## SERVICE TECHNICAL INFORMATION

### ONE POINT REPAIR

REF. NO. : SI-97-019  
CUSTOMER RELATION SERVICE DIV.

MODELS : Z-M2800/M2900/VM280/VM290, NSX-F9/V800/V900  
SUBJECT : No power/Sound Distortion due to power IC defect.  
CONTENTS : Due to power IC(STK-419-\*\*\*defect, it is caused to no power or sound distortion. It requires to modify following contents to all repair items when replace in the above mentioned power IC.

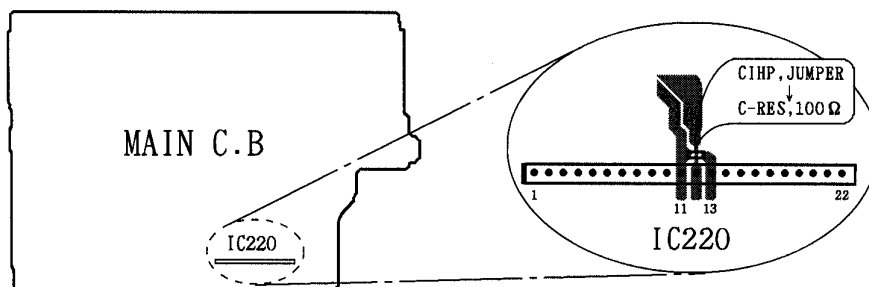
MEMO : This modification is required to do all in the above mentioned models for repair even power IC is not damaged.

REMEDY : To replace parts from chip jumper to chip resistor,  $100\Omega \cdot 1/8W$ , between pin① and ⑬ of IC220.

\* Applicable parts. : STK-419-130  
STK-419-140A  
STK-419-150

Ref.	PARTS CODE	PARTS NAME
	88-128-101-010	C-RES, 100Ω 1/8W
